**DRAFT MEETING NOTES**  
**Tech-to-Tech Meeting/Call with EPA - Surface Sediment Sampling Stations**  
**Portland Harbor Superfund Site Pre-RD Investigation and Baseline Sampling**  
**CERCLA Docket No. 10-2018-0236**

Technical Phone Call, June 4, 2018, 2 to 4 PM PDT

**Figure 1. Site-wide TOC Distribution**

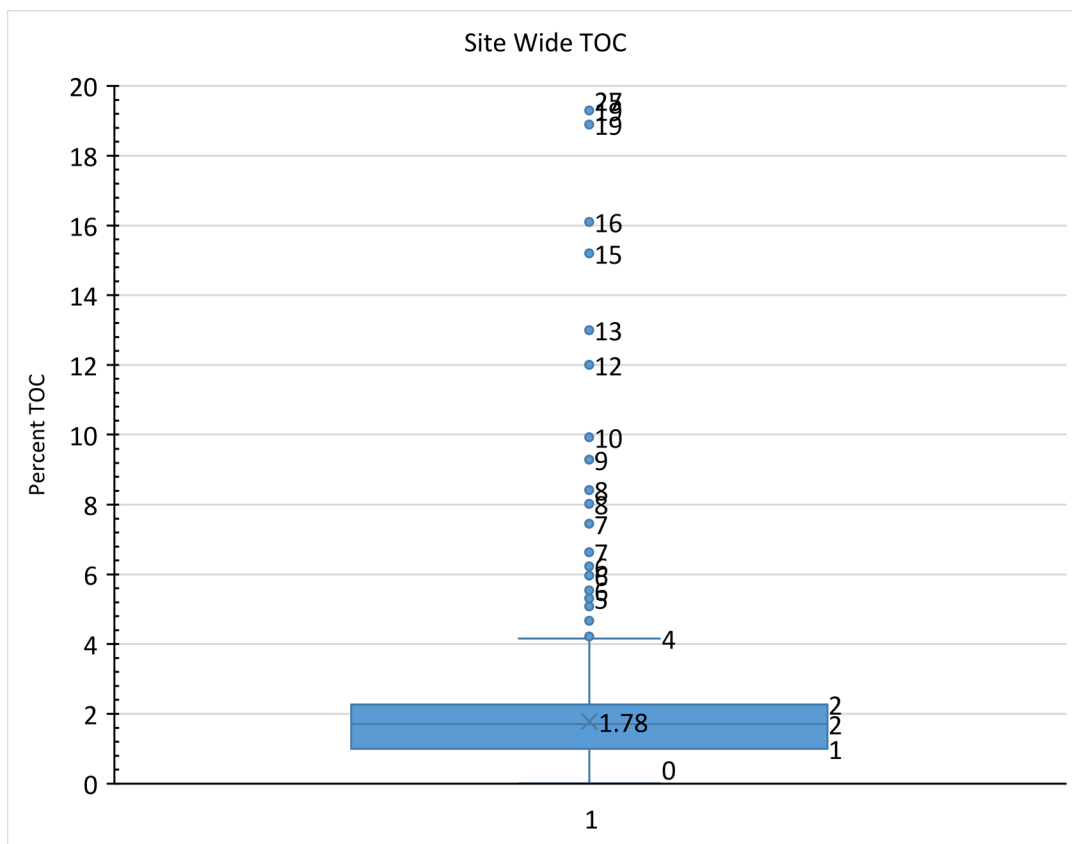
The site-wide average TOC in surface sediment is 1.78 percent and the median is 1.71 percent. As shown in the Figure 1 below, the 25th and 75th quartiles respectively are 1 and 2%. These values are slightly higher for surface sediment samples located outside of the SMA footprints (areas not designated for active remediation).
